# Gate Burton Energy Park

Applicant Responses to Further Written Questions (ExQ2)  
Document Reference: EN010131/APP/8.20  
October 2023

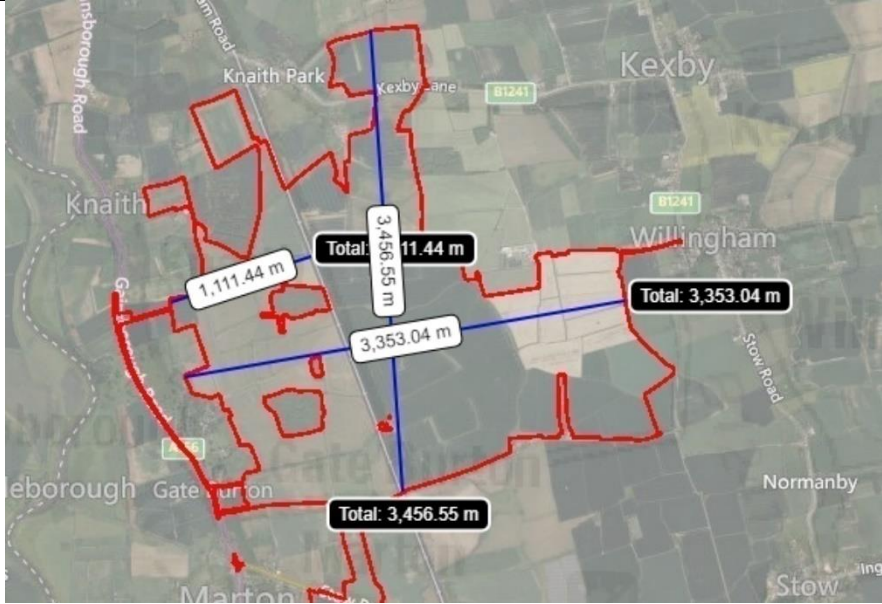
ExQ	Respondent	Question	Applicant's response
Q2.7.1	Nottinghamshire County Council, Lincolnshire County Council, The Applicant	<b>Updated Archaeological Method Statement</b> Confirm that the suggested amendments to the AMS satisfactorily address the issues previously raised.	The Updated Archaeological Mitigation Strategy submitted at Deadline 3 contained updates to the Roles and Responsibilities section following a request from Lincolnshire County Council. These changes were also agreed with LCC's Archaeological Advisor prior to submission at Deadline 3.
Q2.7.2	The Applicant	In Compulsory Acquisition Hearing 1 a note of action points identified at Action 2 an action for the Applicant to provide a 'Description and explanation of the necessity to retain land within the Order Lands where no development is taking place including the Heritage Buffer and land around Knaith Park.' In the Applicants Post hearing submission on CAH1 at 11.1.1 and 5.6.9 only the land at Knaith Park is directly referenced. The review of the rights sought for Knaith Park and any necessary updates or amendments will be provided at deadline 4 is welcomed. However, the point also covered land within or identified as Heritage Buffer. It was suggested CA was necessary to retain control over the land and to ensure it was managed to support the heritage function and in effect ensure the land continued to contribute to the setting of the historic assets. It was suggested this would be further explained including that this would be required to prevent the erection of buildings,	<b>Plots 3/4 and 3/1</b>  The heritage buffer area that runs across all or parts of three fields around the scheduled monument of Heynings Priory is required to remain free of development in order to conserve an aspect of the setting of that monument that contributes to its heritage value; namely, an understand of the local topography around the site where it sits within a hollow 'bowl'. It also preserves in situ archaeological remains identified through geophysical survey that are likely to have an association with the scheduled monument. The rationale for this is discussed in Paragraphs 7.10.21 to 7.10.23 of Chapter 7: Cultural Heritage [APP-016]. It serves to reduce an otherwise significant effect to a not significant level. This heritage buffer is also utilised for hedgerow planting which contributes to the Scheme's biodiversity net gain (BNG) calculations. The field to the east with the waterbody is also required to facilitate an internal access road around the perimeter of the field.

ExQ	Respondent	Question	Applicant's response
		<p>ensure the land remains open etc. This further explanation and mitigation is not directly set out in the statement of reasons or secured within any of the documents. Can the mitigation and management of these areas be clearly set out and shown where and how it is secured and therefore why it is necessary to be the subject of CA and the necessary documentation updated.</p>	<p><b>Plots 5/3, 5/5, 5/6, 5/7, 10/4 and 10,3</b></p> <p>The heritage buffer area to the east of Gate Burton, between the estate and Burton Wood is required to remain free of development in order to conserve an aspect of the setting of the non-designated Gate Burton Park and the Grade II* listed Gate Burton Hall that contributes to their heritage values; namely, a connection to the woodland to the east and views over farmland from within the park. The rationale for this is discussed in Paragraphs 7.10.30 to 7.10.36 of Chapter 7: Cultural Heritage <b>[APP-016]</b>. It serves to reduce an otherwise significant effect to a not significant level. This heritage buffer is also required for hedgerow planting and to facilitate an access road.</p> <p><b>Plot 10/3</b></p> <p>The heritage buffer area in the square area of land to the south of the Solar Energy and Storage Park is required to remain free of development in order preserve in situ archaeological remains that were identified during trial trench evaluation. The rationale for this is discussed in Paragraphs 7.10.87 to 7.10.88 of Chapter 7: Cultural Heritage <b>[APP-016]</b>. It serves to reduce an otherwise significant effect to a not significant level. This heritage buffer is also required to provide ecological mitigation in the form of habitat for ground nesting birds such as Lapwing.</p> <p><b>Plots 2/1, 2/2 and 2/3</b></p>
